# INSTALLATION OF UNIVOLT V IN 1969 TRAILERS

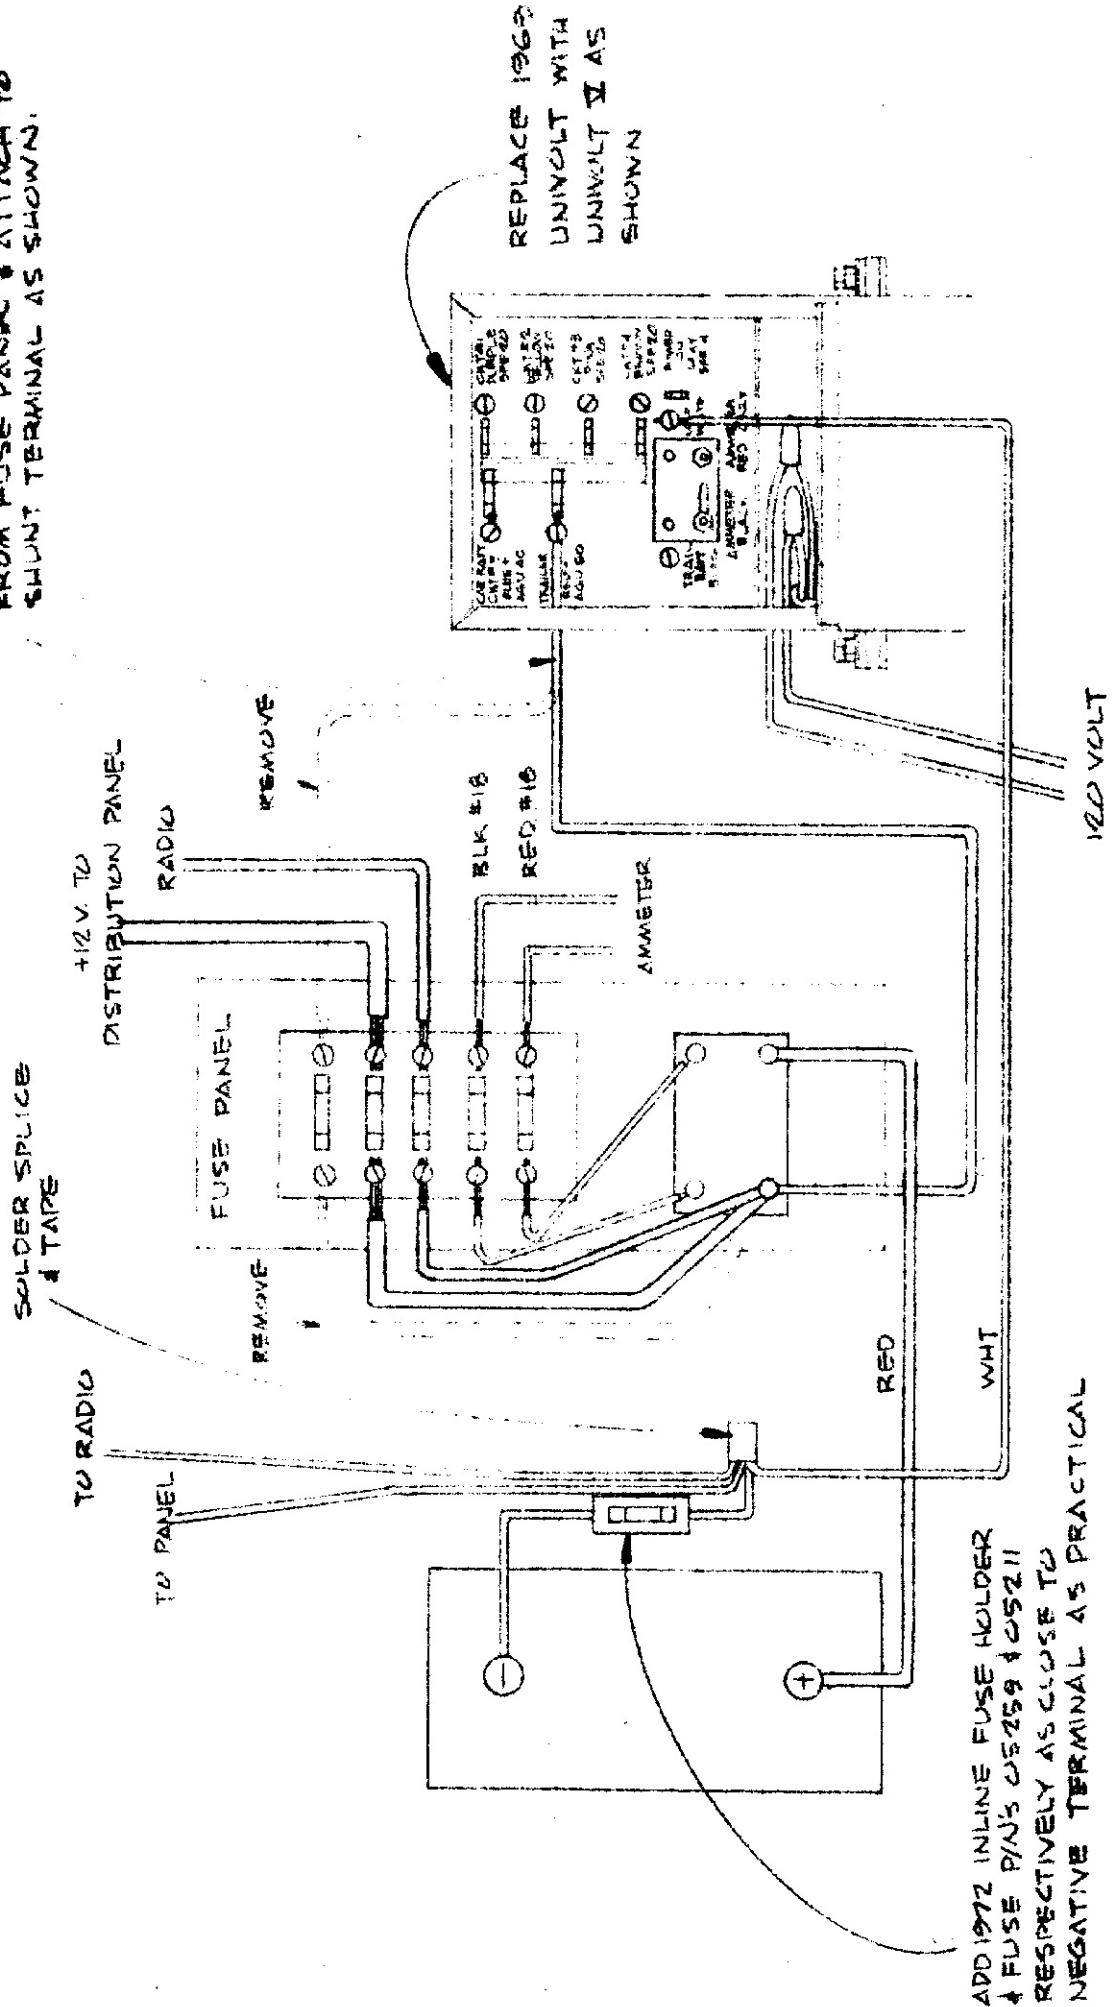
REMOVE UNIVOLT'S +12V. WIRE FROM FUSE PANEL & ATTACH TO SHUNT TERMINAL AS SHOWN.

ADD 1972 INLINE FUSE HOLDER  
 ↓ FUSE P/N'S 05259 & 05211  
 RESPECTIVELY AS CLOSE TO  
 NEGATIVE TERMINAL AS PRACTICAL
